Item #2

Re: City of Rockville Comments on Preliminary Plan 1-03029 (Fortune Parc)

Re: City of Rockville Initial Comments on the Fortune Parc Traffic Study

**TRIP ASSIGNMENT FOR DEVELOPMENT #6**

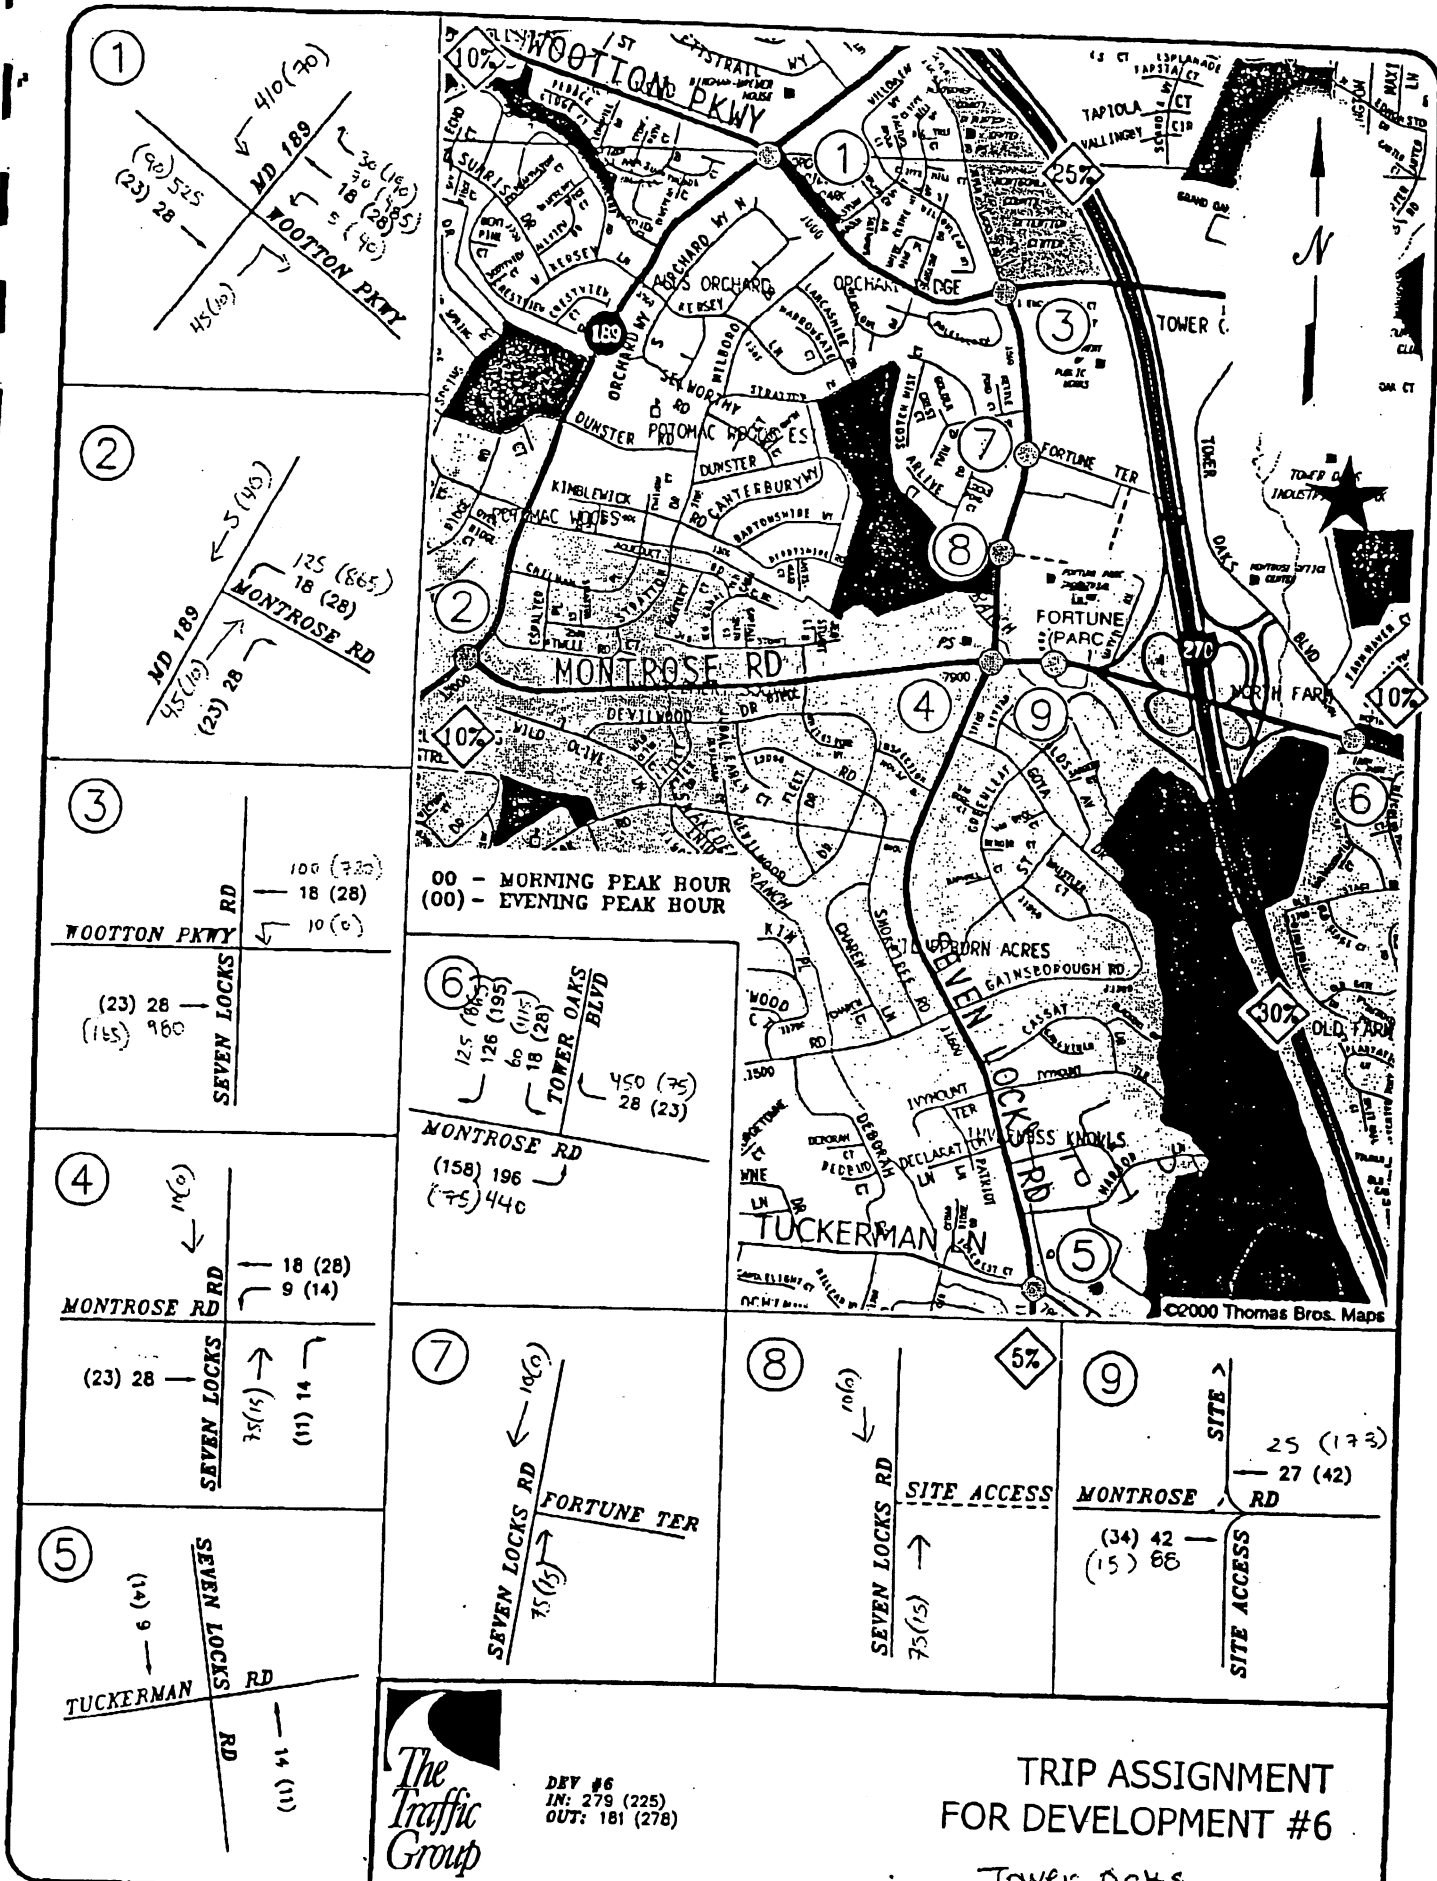
- v. The traffic from Tower Oaks assigned to the road network was not consistent with the approved traffic study for Tower Oaks. The correct assignment (not adjusted for occupied development) is attached. These volumes should serve as the base for the trip assignments in the revision of the traffic study. The result will be a dramatic increase in the congestion levels at the Montrose Road/Tower Oaks Intersection which will show that Fortune Parc will exceed the County's LATR standards, even with the proposed improvement.
